**Response to Regulatory Comments
for
Final Focused Feasibility Study/TI Waiver for MARBO Groundwater
Andersen Air Force Base, Guam**

Item	Page	Section	Comments	Response to Comments
Comments provided by EPA Region IX RPM (M Ripperda) in 7/24/08 email				
Focused Feasibility Study Comments				
1	4, last bullet		Please avoid phrases like “conditions are far too toxic...” Either explain the geochemical problems or delete this sentence. Likely “conditions are not favorable” is better	The last bullet point in section 3.0, page 5 now reads “Groundwater geochemical conditions are <i>not favorable</i> for biological reductive dehalogenation.”
2		2	Please include a short description of island groundwater lenses, particularly vertical chloride gradients and the transition zone. A more detailed explanation also needs to go in the TI Waiver Justification, Section 7. as part of the conceptual site model	An additional bullet point was added to section 2.0, page 3 to provide additional description of freshwater lenses. Cross-sectional diagrams illustrating the relationship between lens thickness, time, chloride concentration, and contaminant concentrations were incorporated. (Figures 3 and 5)

*

TRICHLOROETHYLENE (TCE) IN MARBO LTGM AT WELL D-14

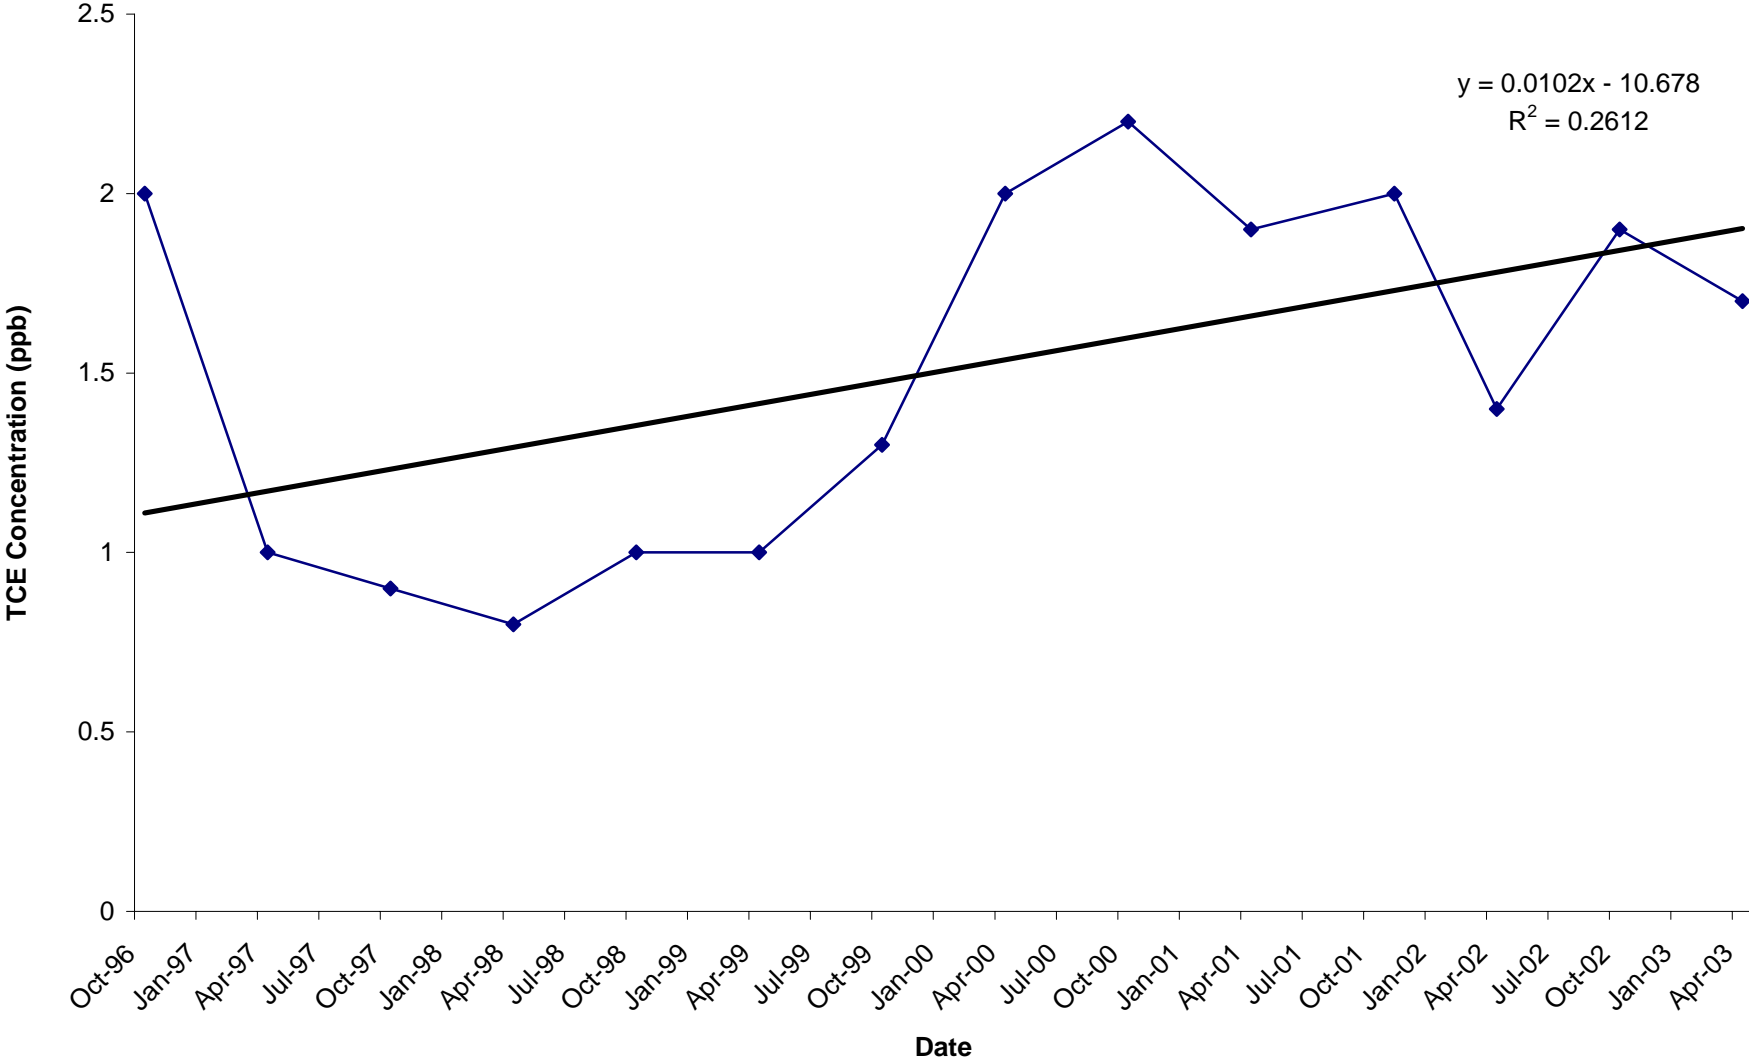
18		Figures	Please add concentration versus time graphs for the deep wells and any key shallow monitoring wells and production wells.	Attachment 1 contains well graphs of contaminant concentration versus time for shallow and deep wells in the vicinity of the TCE and PCE occurrences. Reference to Attachment 1 was made in the second paragraph of Section 8.1.
19		Figure 8	does not show the TI zone..should be depicted here and in cross-section	Acknowledged. Figure 8 was corrected to indicate spatial limits of TI waiver and is now entitled Figure 8-1. Additionally a cross section was added (Figure 10-1).
